NEBRASKA ARMY NATIONAL GUARD SIDNEY RC INTERIOR SUSTAINMENT (REBID)

PROJECT NO. 31030399

A D D E N D U M N O . 1

Project: Sidney RC Interior Sustainment
#310399 (REBID)

DRAWING TITLE:
DEMO PLANS - ELECTRICAL

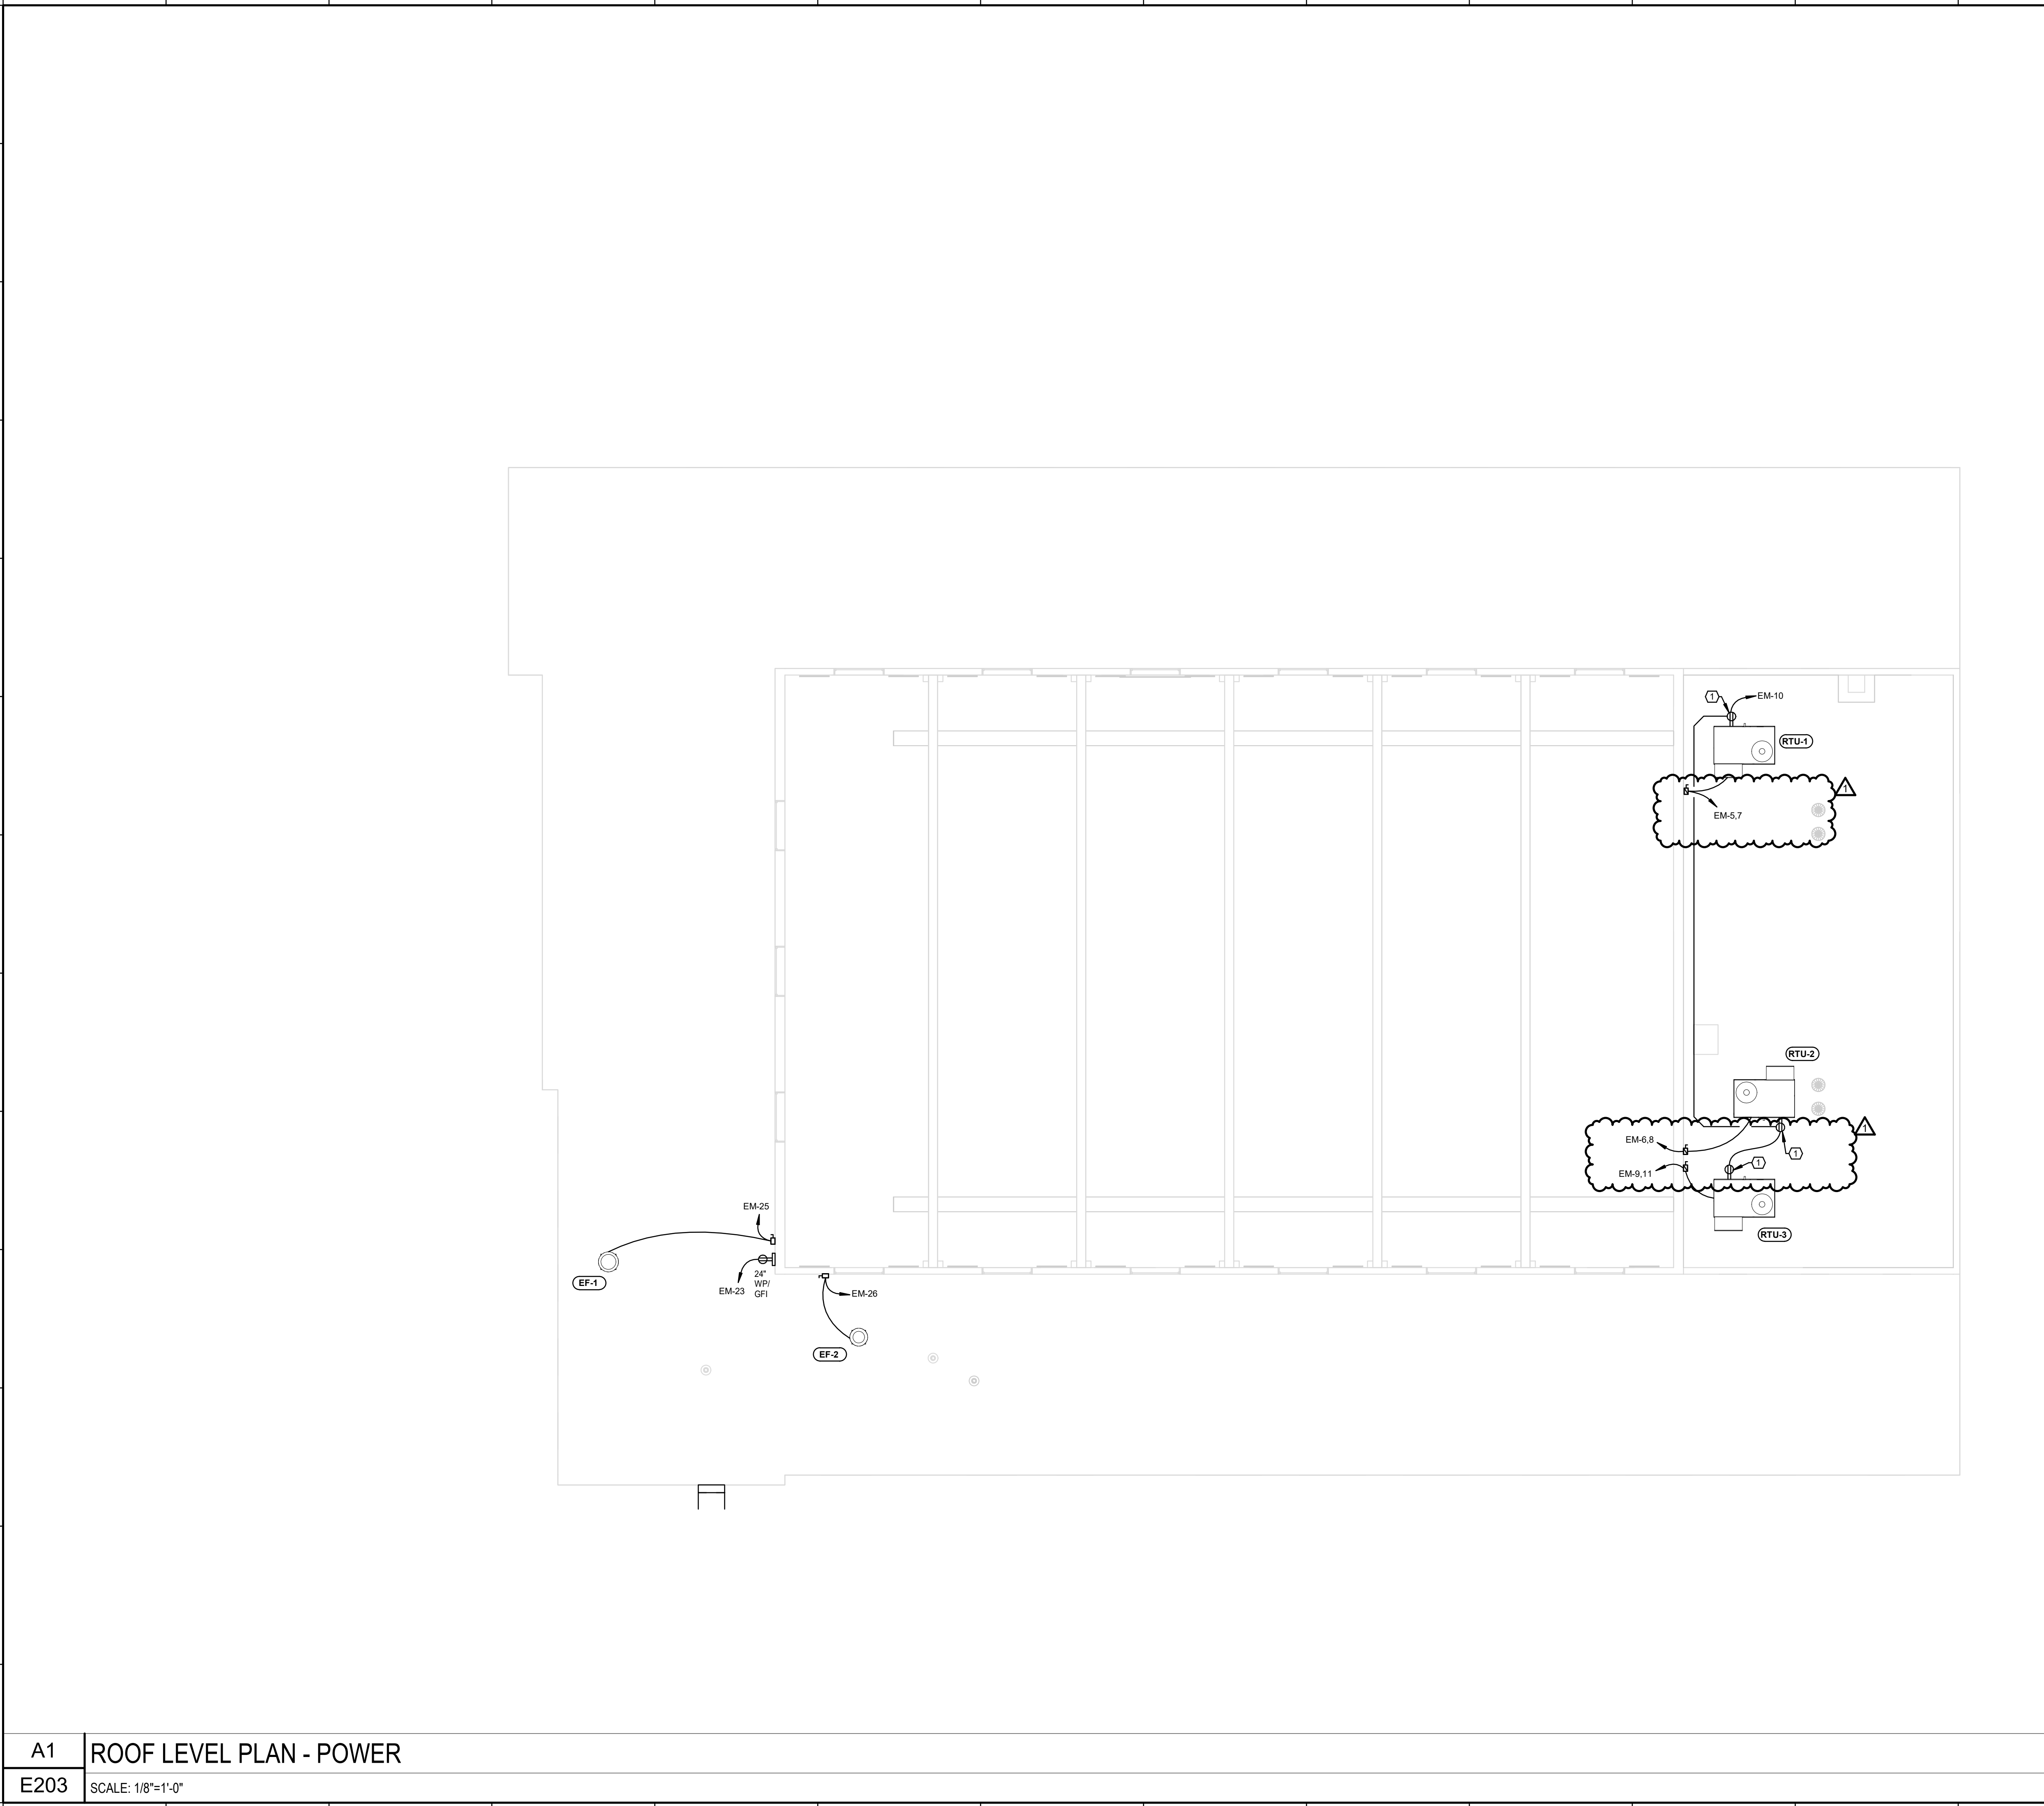
Electrical – See Revised Drawings for More Information**Sheet ED101 – Demo Plans - Electrical**

1. Changed keynote 5 to read: "EXISTING FIXTURES REMOVED BY OWNER. CONDUIT AND WIRING TO BE REROUTED AS HIGH AS POSSIBLE TO BE ABOVE NEW CEILING."
2. Added keynote 7 to read: "AIR HANDLING UNIT HAS BEEN REMOVED BY OWNER."
3. Removed light fixtures and added keynote 5 to Office 102, Office 103, and Entry 100.
4. Added keynote 7 to the two (2) air handling units in Shop 111.
